**Response to NRC
Comments
on
*Assessment Report for
Well 1319 Area***

**Cimarron Corporation's Former
Nuclear Fuel Fabrication Facility
Crescent, Oklahoma**

**License Number: SNM-928
Docket Number: 70-0925**

Re: Docket No. 70-925; License No. SNM-928
Response to NRC Comments on Assessment Report for Well 1319 Area

FIG_8_SS_B_POT_SURF_05_04.mxd

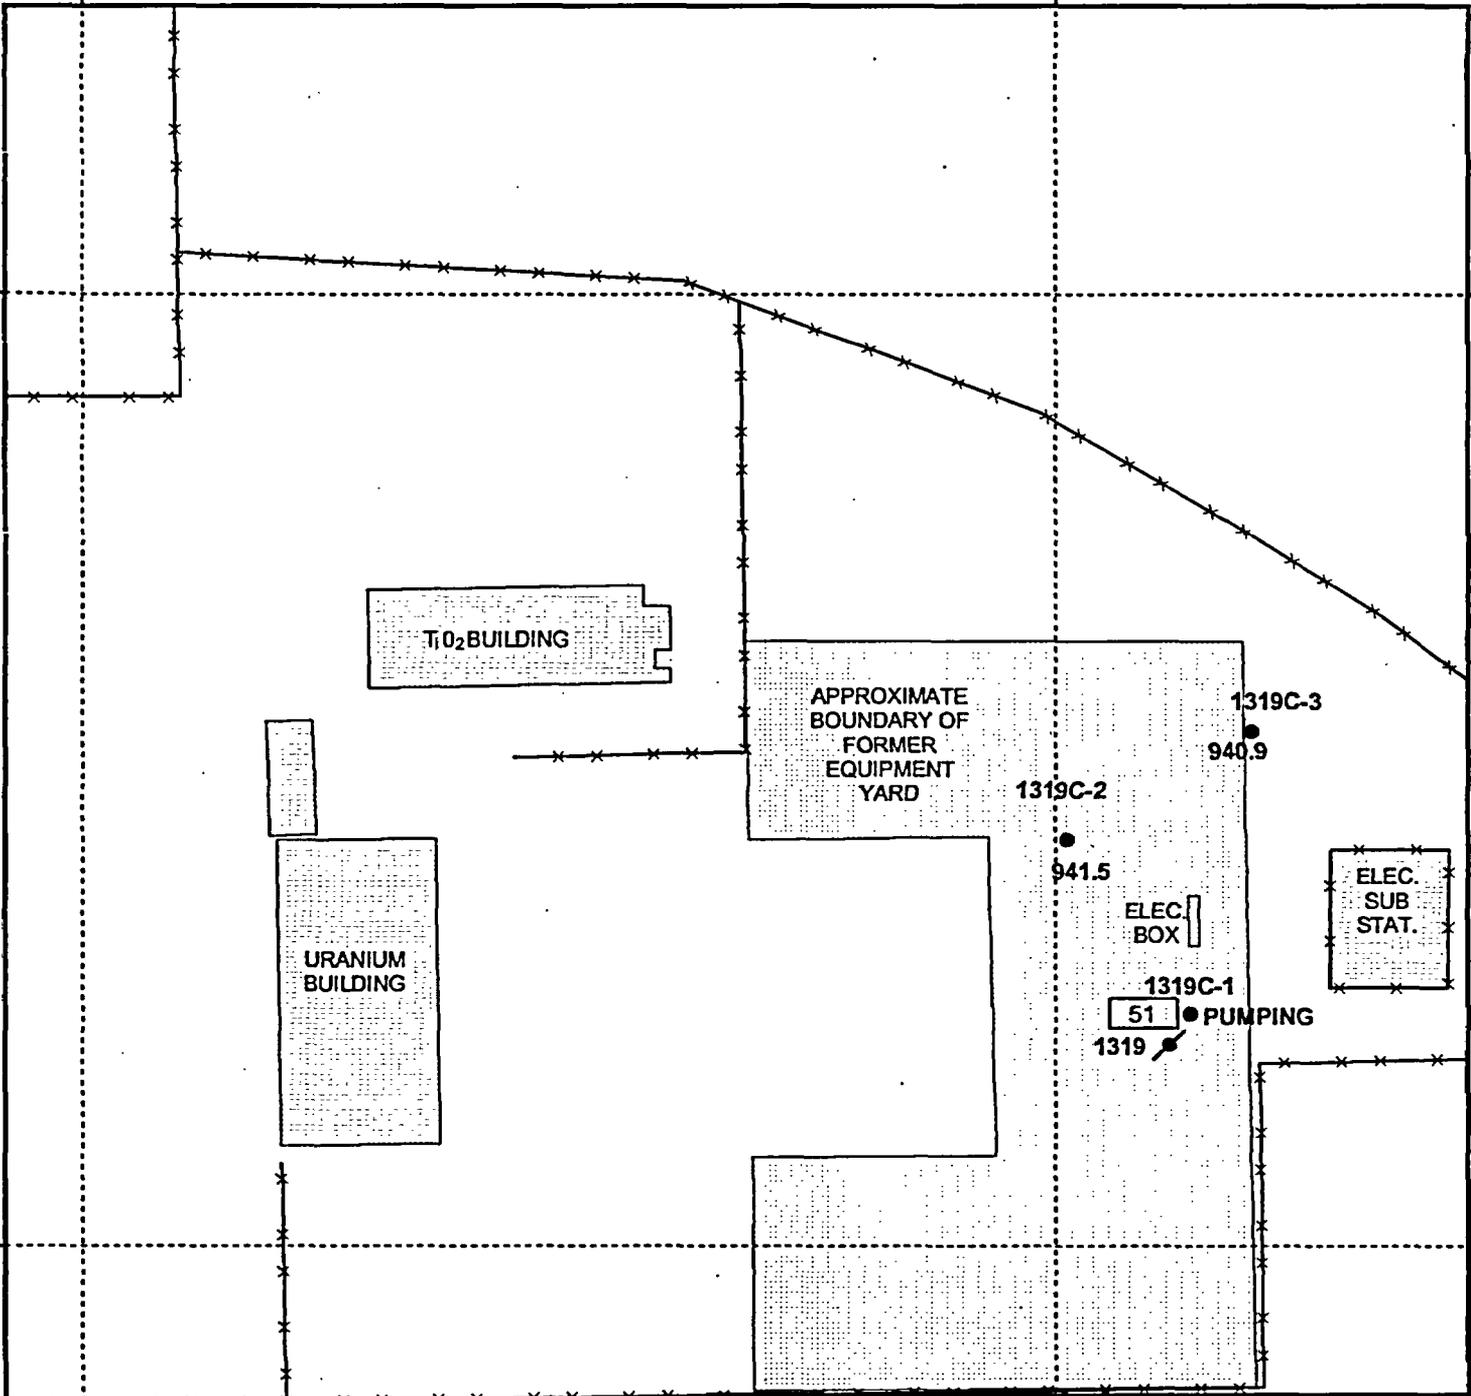
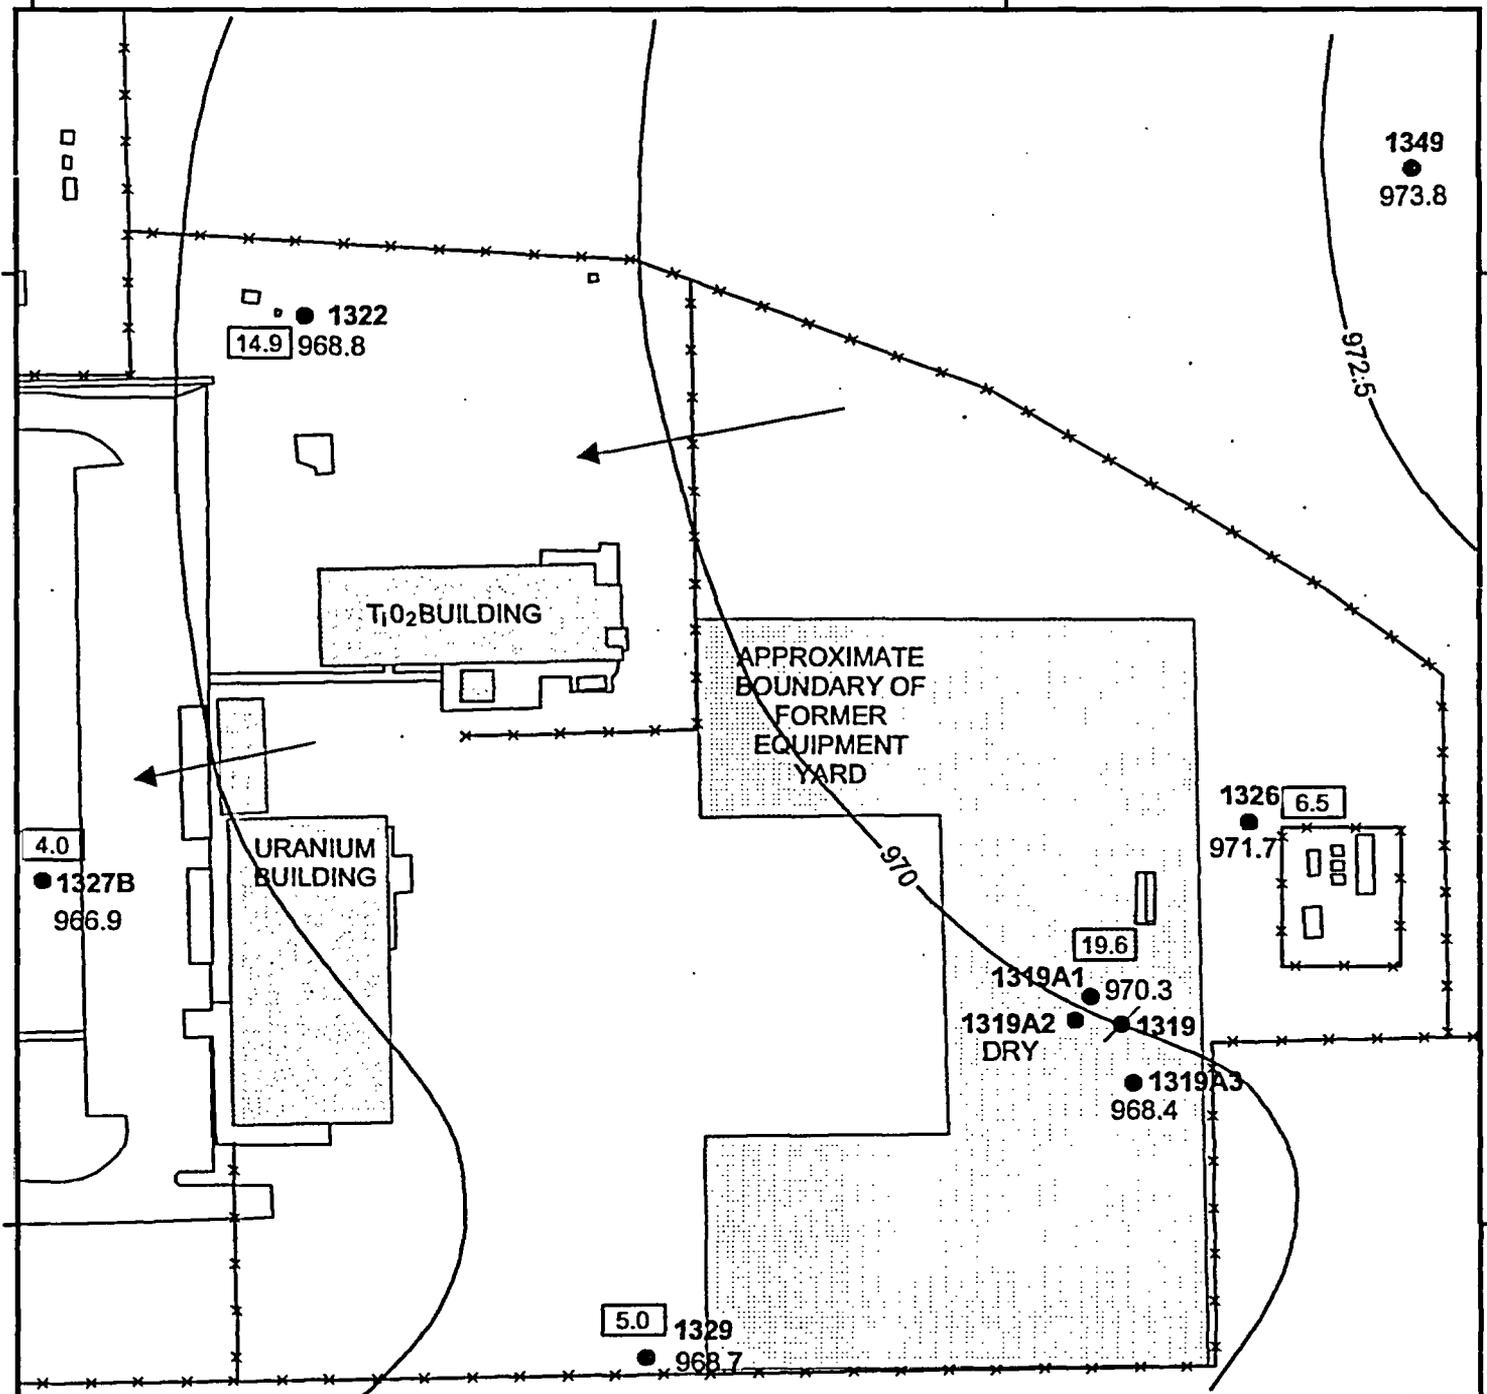
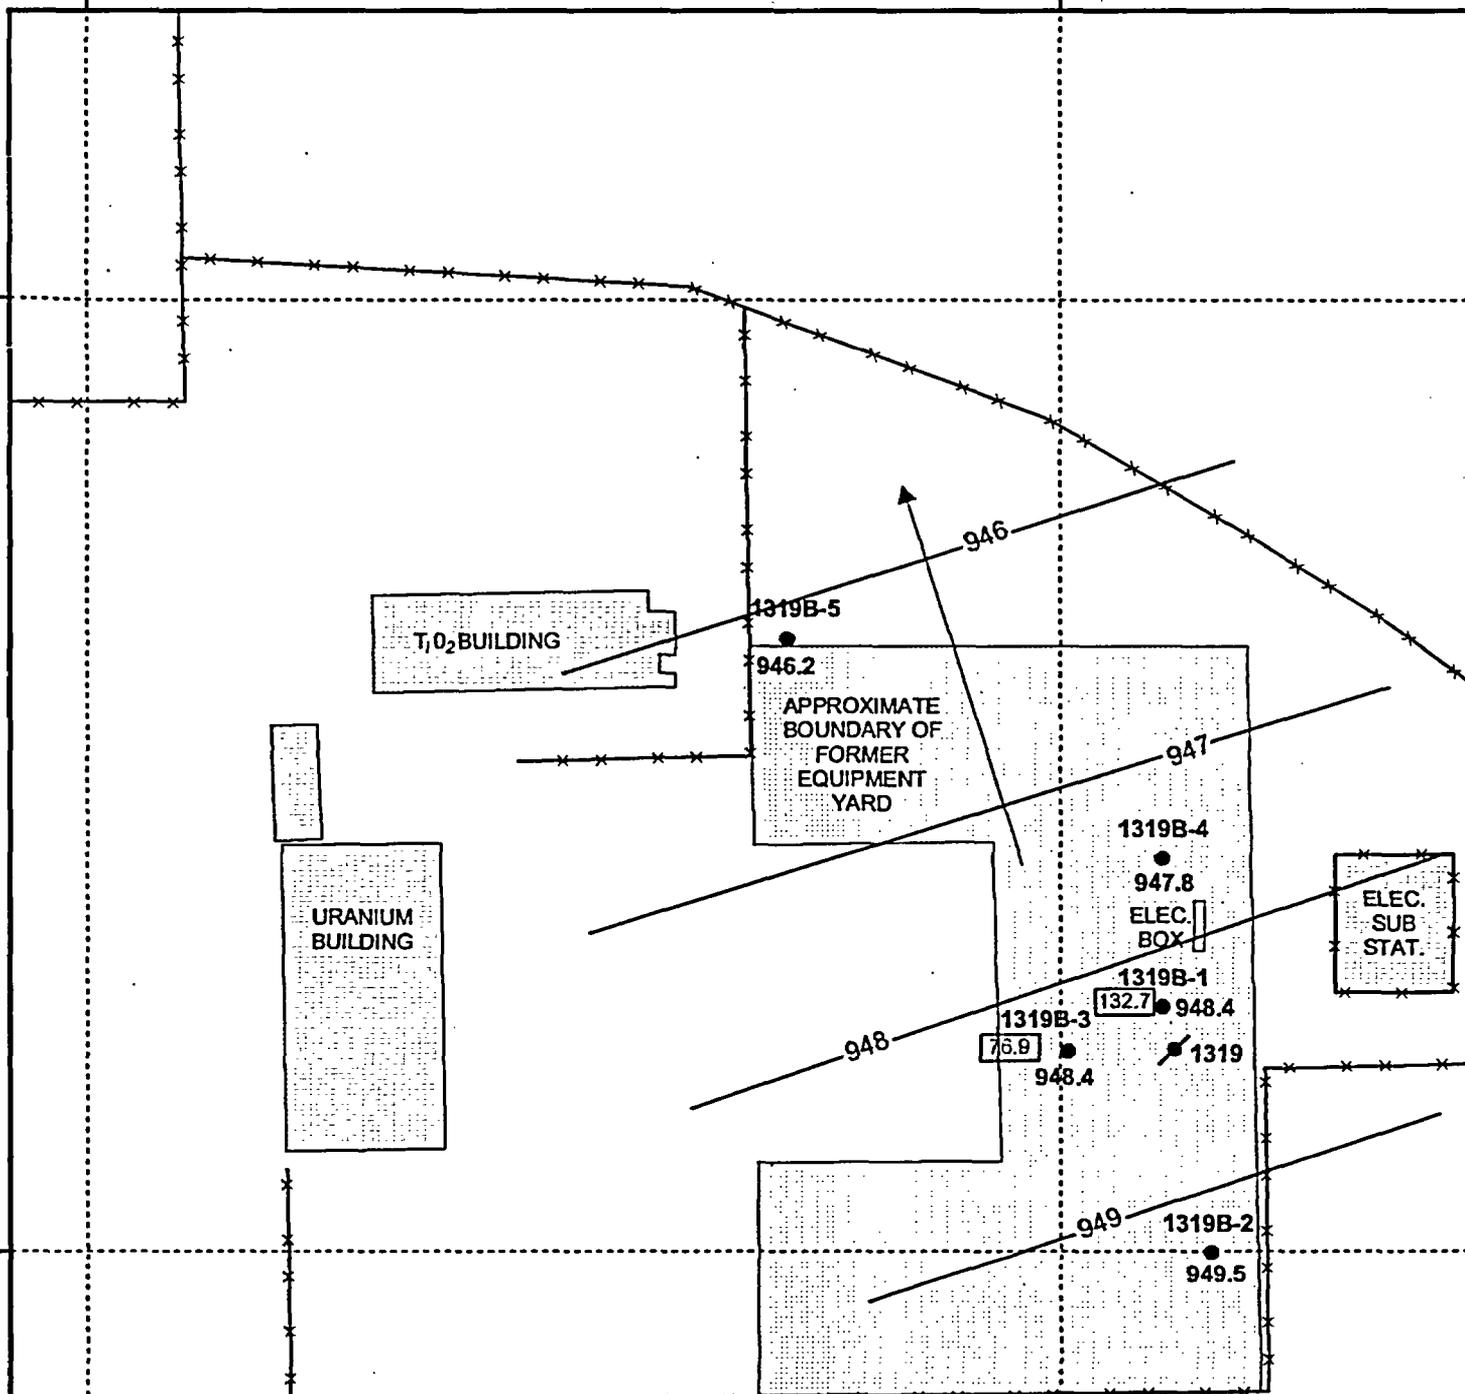
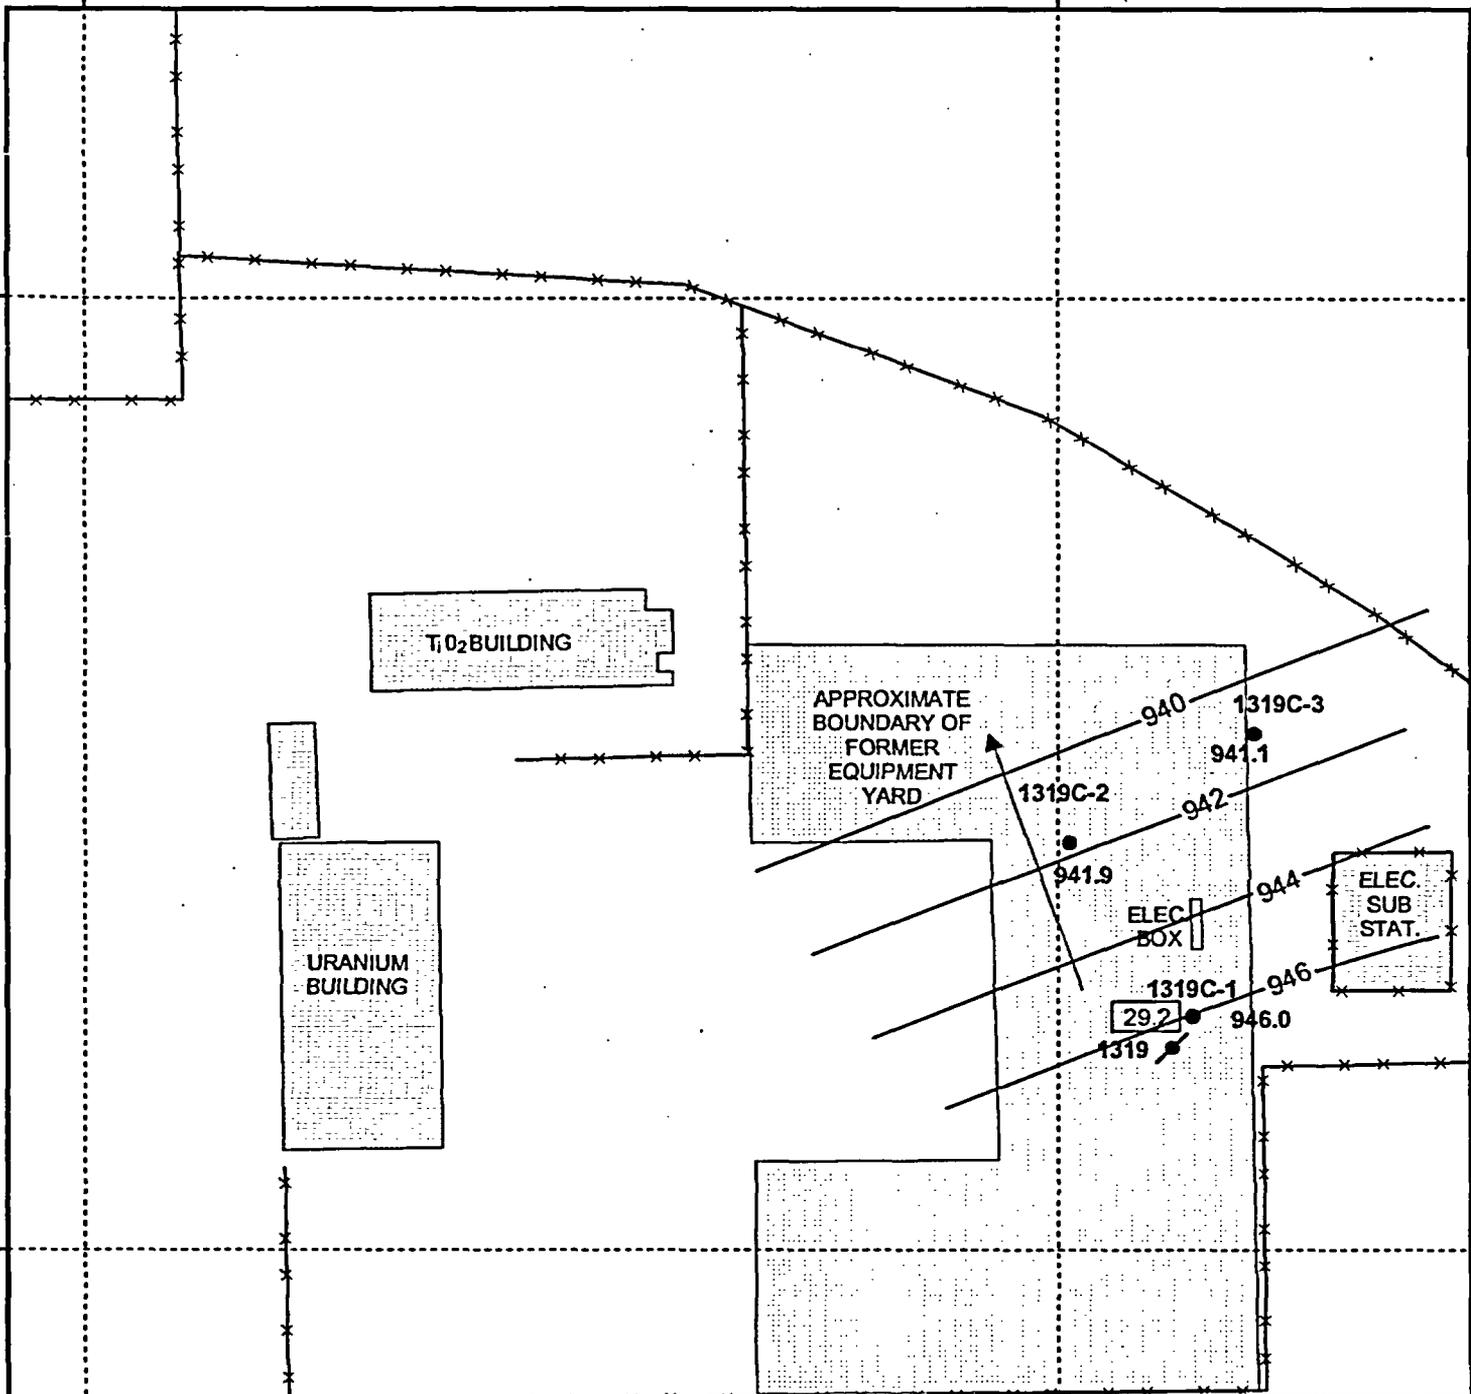
The licensee should provide additional water levels, groundwater flow directions, and total uranium analytical results since the September 2003 sampling event.

Cimarron provided potentiometric surface maps in Figures 8, 9, and 10 for Sandstones A, B, and C, respectively, in "Assessment Report for Well 1319 Area". Those maps have been updated to include total uranium concentration for the September 2003 sampling event. Groundwater elevations were recorded for wells in the Well 1319 area during the December 2003, May 2004, and August 2004 sampling events. Sets of similar figures were created for each of these three events, presenting the potentiometric surface and groundwater flow directions for each of the three sandstone units. Total uranium concentrations are not shown on all figures because only Wells 1319B-1 and 1319C-1 were sampled during some events. Most of the wells in the area were sampled during the August 2004 sampling event, so figures for that event include total uranium concentrations for all wells in the Well 1319 Area that were sampled. These figures are included in this submittal as Attachment 4.
